W0129-03

Inspector's Report on a Licence Application

TO:	DIRECTORS
FROM:	Brian Meaney - Environmental Licensing Programme
DATE:	12 June 2014
RE:	<p>Recommendation to refuse an application for an Industrial Emissions licence from</p> <p>Murphy Environmental Hollywood Limited</p> <p>in relation to an integrated waste management facility, including landfill, at Hollywood Great, Nag's Head, Naul, Co. Dublin,</p> <p>Licence Register W0129-03.</p>

1 Recommendation to refuse the grant of a licence

Figure 1 DAC lining system (source, EIS)

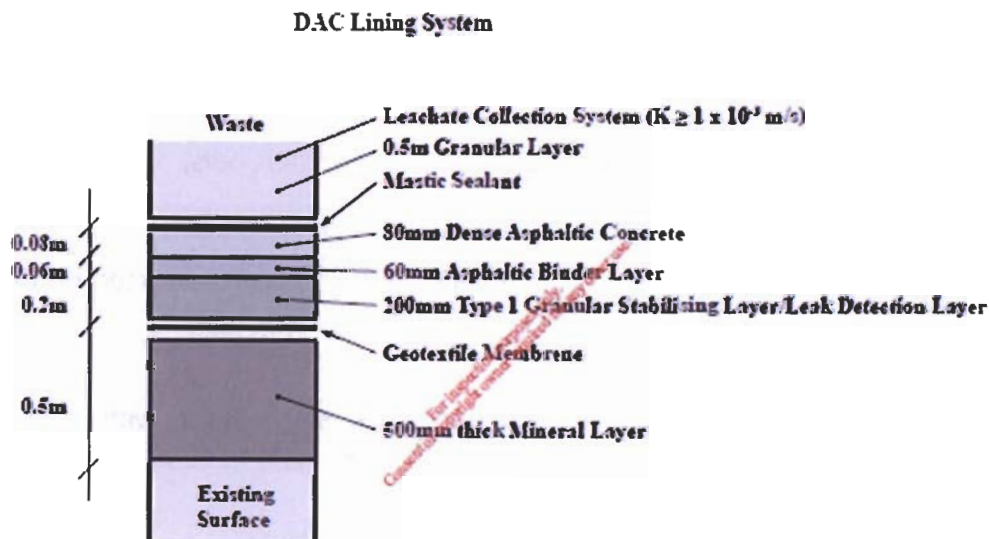
The 500mm compacted mineral layer (lowest part of the lining system) would not normally be proposed as part of a DAC installation but is to be included in this instance due to the requirements of the Landfill Directive, as discussed in more detail in the following paragraphs. The 200mm thick granular stabilising sub-base would not normally be used as a leak detection layer but is proposed in this instance as an additional safeguard and an early-warning system in the event of the DAC liner leaking. The applicant has stated that on-site testing at other sites shows that dense asphaltic concrete installations have achieved a hydraulic conductivity of $1 \times 10^{-15} \text{m/s}$ – i.e. complete containment.

The Agency should be sympathetic to this position in this instance if for no other reason than the artificially completed geological barrier proposed is itself under risk from groundwater rebound (as described in more detail in sections 6.1 and 11 and Appendix 1) and could in time find itself saturated and below the water table. If this occurs, then the geological barrier no longer fulfils its design function of providing a barrier to protect groundwater and attenuate contaminants. This being the case, the proposed manner of artificially completing the geological barrier, and the liner system as a whole unit, cannot satisfy BAT (i.e. the Landfill Directive).

Hollywood, Naul, Co. Dublin	GCU0146033	<p>Figure 1</p>
<p>Geosyntec consultants</p>	<p>Environmental Protection Agency (EPA) Ireland</p>	
Delph, UK	14-05-2014

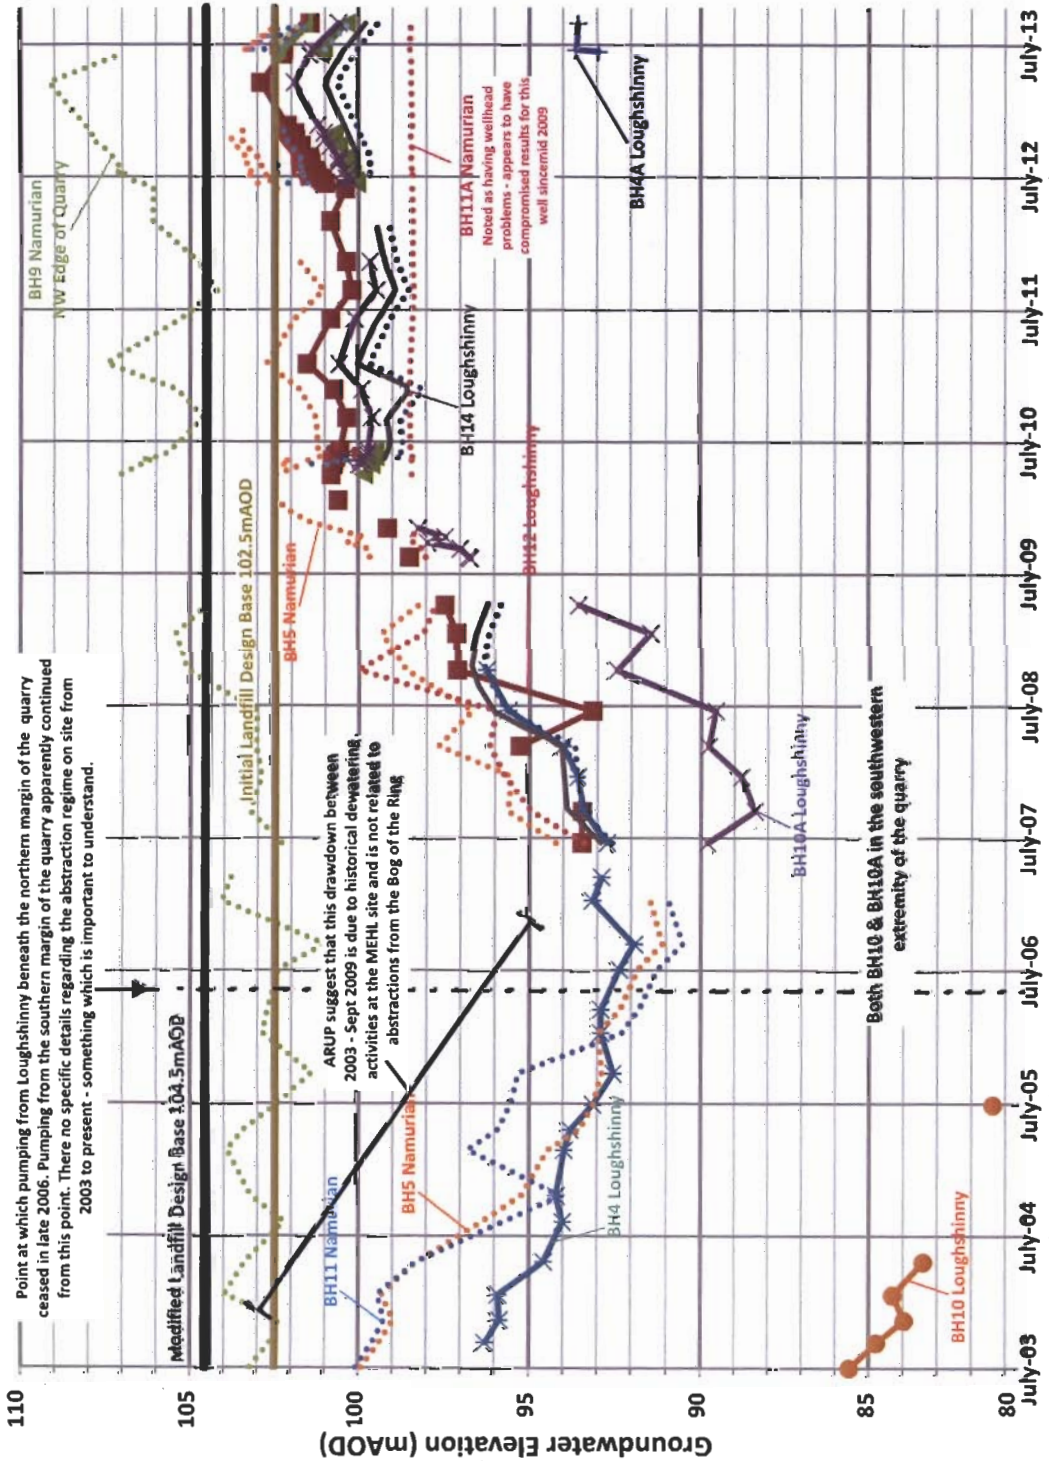
2. Improved well data for the proposed non-hazardous waste cell and new inert cell. In some of the southern area (southwest quadrant specifically) there appeared to be insufficient well points. As only the Loughshinny is present only one additional well point was expected to be needed. Where it could not be demonstrated that suitable monitoring wells already existed then additional ones were expected to be needed. Geosyntec highlighted one important location (see Figure 1);

The actual site investigation and well installation programme completed by the Applicant in 2013 had some limitations (refer to Figure 1 also for actual locations), some of which are expected to have compromised overall understanding, data collection and conceptual site model (CSM) development. The main points we would make can be summarised as follows:

Groundwater Hydrographs MEHL Site 2003 - 2013

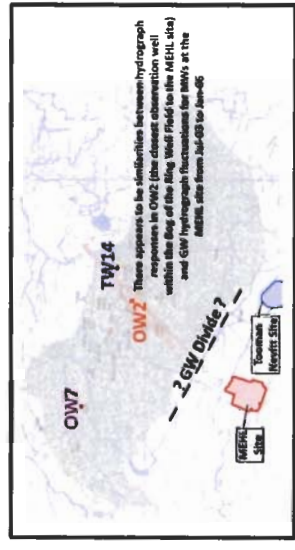
Finally it is noteworthy that the monitoring well hydrographs of drawdown within the Bog of the Ring well field from the July 2003 start-up (also shown on Figure 2) follow a remarkably similar trend to MEHL monitoring wells (which may be more than a coincidence, based on the limited Arup reported data). Arup put this down to on-site abstraction which reportedly partially ceased in late 2006 (in the northern site area; P36 of Bog of the Ring report). Arup also state that groundwater levels in recent monitoring rounds have been observed to be increasing, to them indicating that levels may be rebounding following cessation of dewatering at the quarry. However, we also know that the Bog of the Ring abstraction dropped to around 2,500 m³/day (as an average) by 2011, down from an average of >3,500 m³/day in 2006 and probably 2007.

Relatively strong correlation between OW2 and MEHL onsite Monitoring Well Hydrographs. As would be expected, the magnitude of fluctuations is less pronounced to the south of the divide, outside the abstraction catchment.

Groundwater Drawdown (Point Measurement in Monitoring Wells & Inferred Contoured Plot) following 7 day Pumping Test from BH17 (prior to cessation)	
Hollywood, Naul, Co. Dublin	GCU0146033
Geosyntec consultants	Environmental Protection Agency (EPA) Ireland
	Figure 3
Delph, UK	14-05-2014

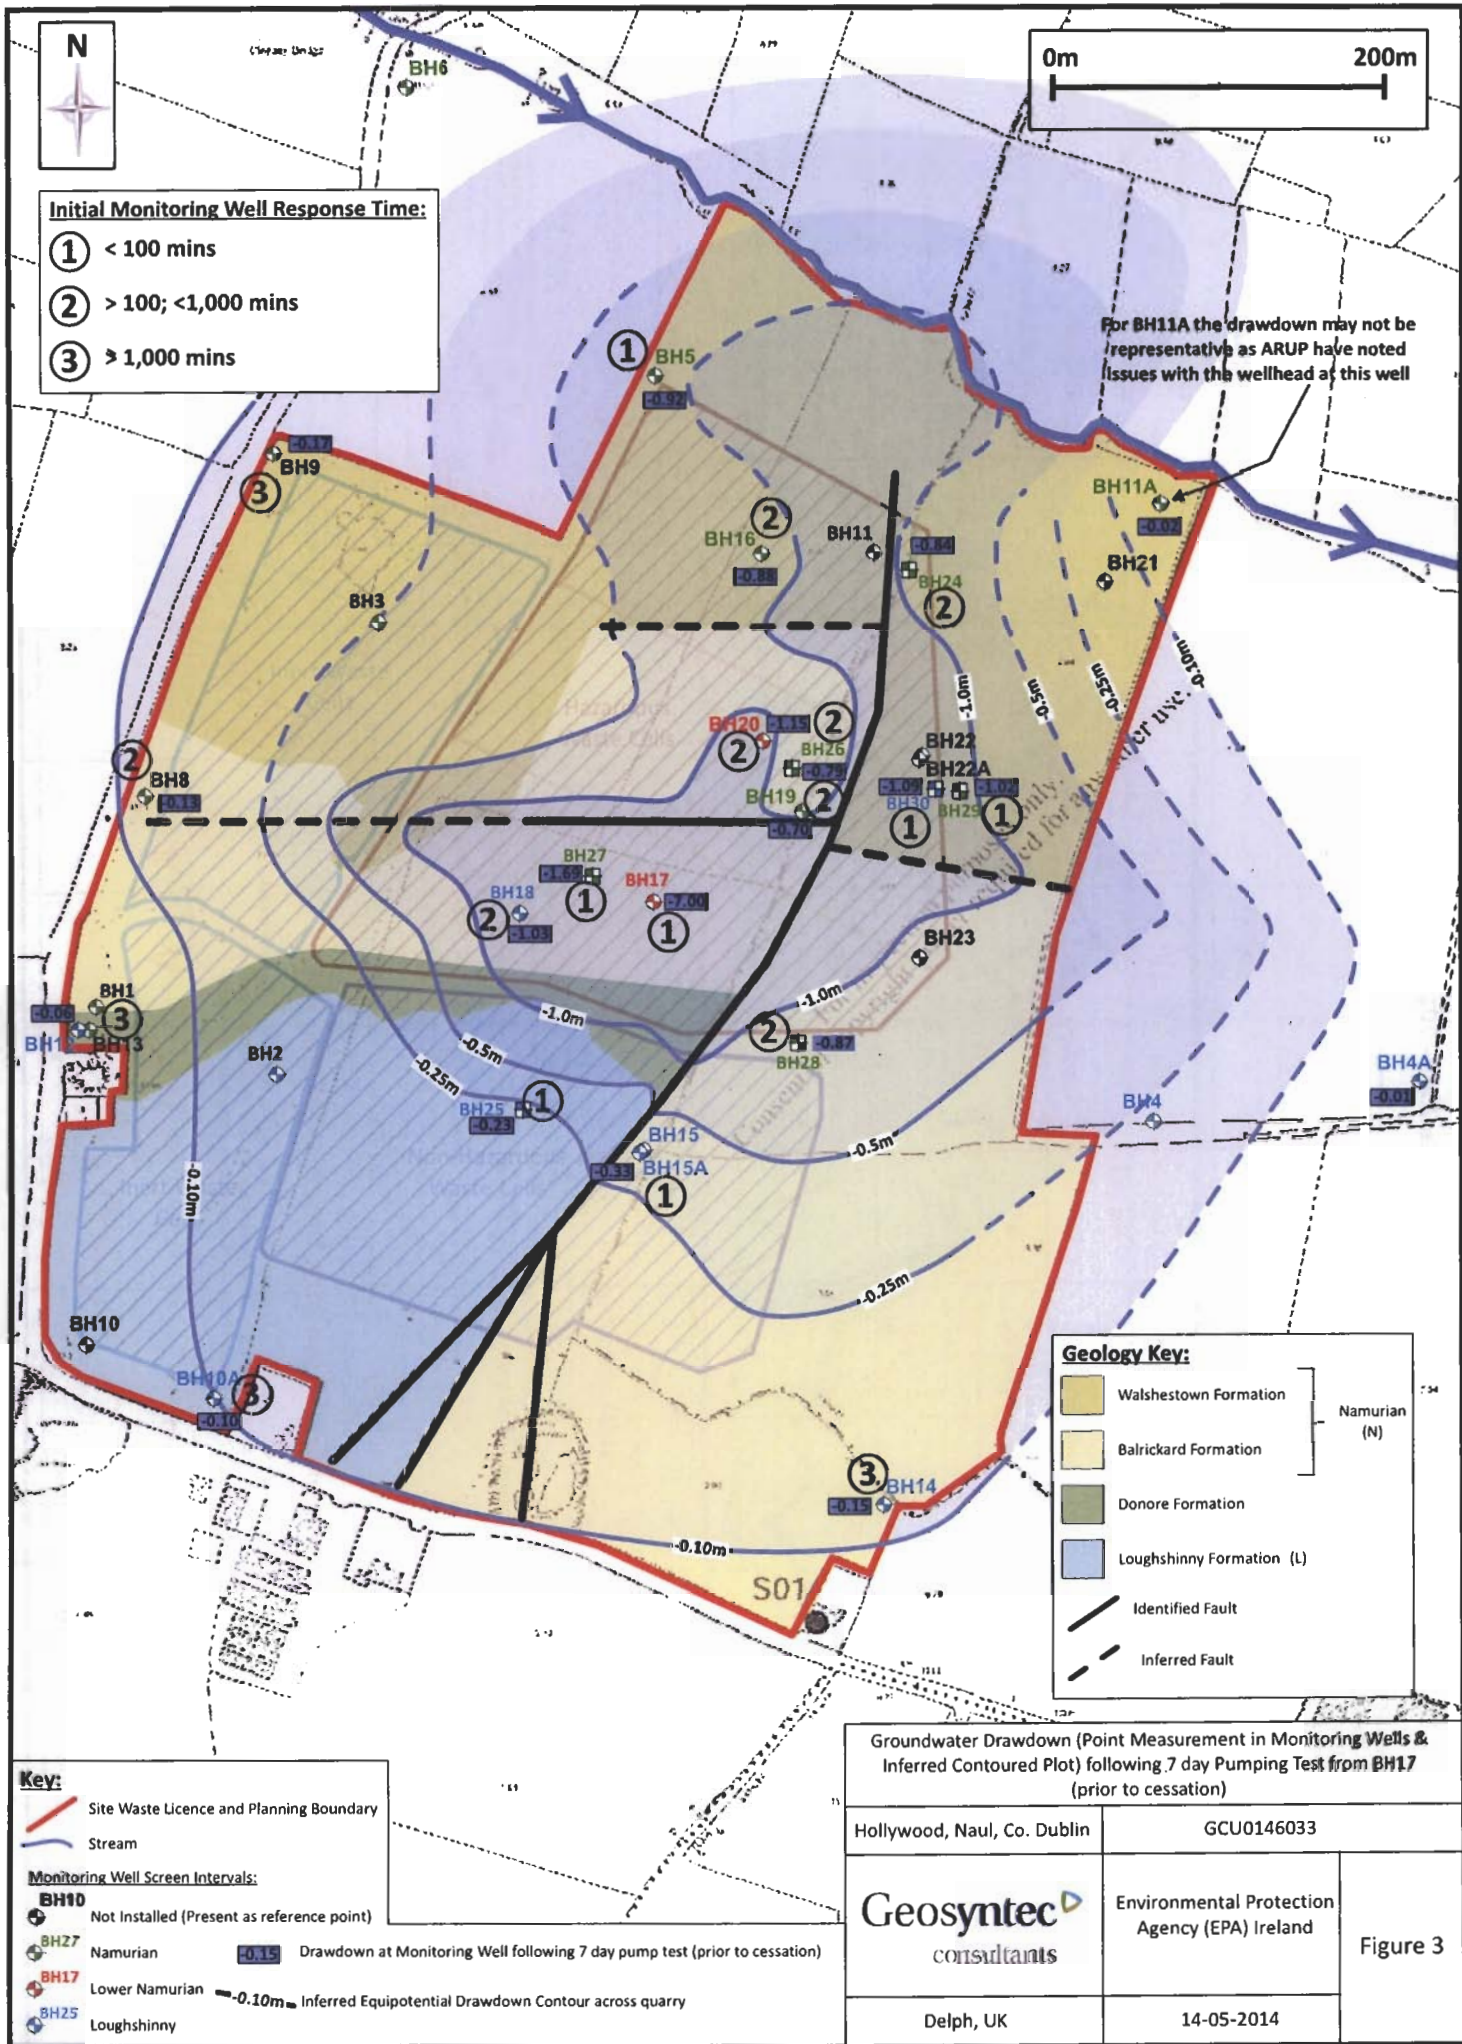
Geosyntec has tried to assess the distribution of early well groundwater level responses (from the Arup curve analysis plots) to the 7-day pump test and this has been summarised as part of Figure 3. Early responses (<100 minutes) were seen close to the pump test well, to the east of the main fault and just north of the secondary west-east fault, to the south close to the main north to south fault line and in BH5 up in the northwest corner (all shown by an encircled 1 in Figure 3). This early data suggest the faults matters and are associated with a preferential hydraulic connection.

The BH5 result (overall nearly 1m of drawdown reported in this well located >300m to the north of the pump test well) suggests a linear connection north-south that is out with the main site N-S fault zone but perhaps more aligned to the regional fault. Other peripheral site wells typically had the slowest response, as to be expected, however it is noteworthy that of these peripheral wells BH8, located west of the pump test well, had the earliest response and this is located along the apparent line of the west to east fault (has been given a 2 response time; refer to Figure 3).

However, a Geosyntec schematic of the inferred 'steady state' drawdowns across the quarry towards the end of the 7 day pump test is provided (also in Figure 3). Whilst it appears clear that the fault zones exert influence on aquifer hydraulics, with propagation of the drawdown appearing most pronounced along their route, there is also general propagation of drawdown across it (most notably in BH28-BH30). Overall drawdown to the south is less marked, as might be expected given this area has Loughshinny close to or at surface.

Whilst Figure 3 does suggest the fault zone acts more as a conduit for groundwater than a barrier to it, the pump test 7 day piezometry (Figure 4) also suggests relatively radial flow to the pump test well (BH17) for a fracture flow system (i.e., the aquifer is not that anisotropic). The groundwater level decline in BH17, which does not appear to have been corrected for well losses, is shown in Graph 5 of the Arup Appendix H Pumping Test document (included here-in within Appendix A). It suggests the drawdown had not stabilised after 7 days, indeed there was an increase in drawdown again after about 1000 minutes. This suggests a boundary effect coming into play, perhaps linked to a preferential groundwater source or flow zone (perhaps the fracture zone) becoming somewhat depleted. If this was illustrative of the fault zone then it may suggest it is limited in the context of being a preferential pathway.
